Access Compliance Report

Public Rights-of-Way

(Curb Ramps)

Intersection ID: 10023986	Main Street: COPPER_WY	Cross Street: N/A	Location: E
ADA ID: 2EB264B55840	Ramp Type: Perp	Initial Pass/Fail: Fail	Overall Compliance: No
		Severity Score: 22.5	
Codes/Mitigation Info/Possible Solution		Field Measurements/Component Compliance

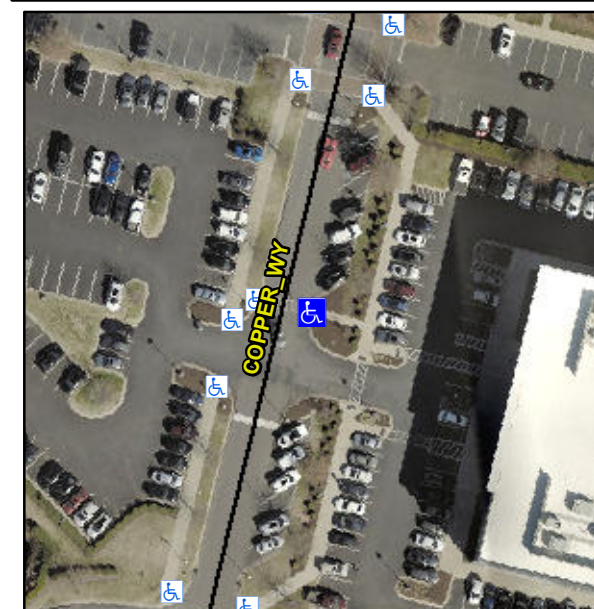
R304.5.1, R304.5.3

Compliance	Description	Data	Compliance	Description	Data
N/A	Ramp Length (in)	348.0	Yes	Ramp Slope (%)	10.3
No	Ramp Width (in)	46.0	No	Ramp XSlope (%)	2.1
N/A	Flare Type LT	N/A	N/A	Flare Type RT	N/A
N/A	Flare Slope LT (%)	N/A	N/A	Flare Slope RT (%)	N/A
N/A	Flare Traversable LT?	N/A	N/A	Flare Traversable RT?	N/A
N/A	Landing Length (in)	N/A	N/A	DWS Provided?	N/A
N/A	Landing Width (in)	N/A	N/A	DWS Contrast?	N/A
N/A	Landing Slope (%)	N/A	N/A	DWS Length (in)	N/A
N/A	Landing X Slope (%)	N/A	N/A	DWS Full Width?	N/A
N/A	Landing Curb? (Y/N)	N/A	N/A	DWS Offset (in)	N/A
N/A	Shared Landing?	N/A			
N/A	Gutter Ponding?	N/A	N/A	Gutter Slope (%)	N/A
N/A	Gutter Lip Ht (in)	N/A	N/A	Gutter X Slope (%)	N/A
N/A	Painted X Walk1?	Yes	N/A	Painted X Walk2?	N/A
	X Walk 1 Direction	To W		X Walk 2 Direction	N/A
N/A	X Walk 1 Width (in)	55.5	N/A	X Walk 2 Width (in)	N/A
	X Walk 1 Slope (%)	0.7		X Walk 2 Slope (%)	N/A
	X Walk 1 X Slope (%)	0.4		X Walk 2 X Slope (%)	N/A

Remove & Replace Entire Ramp.
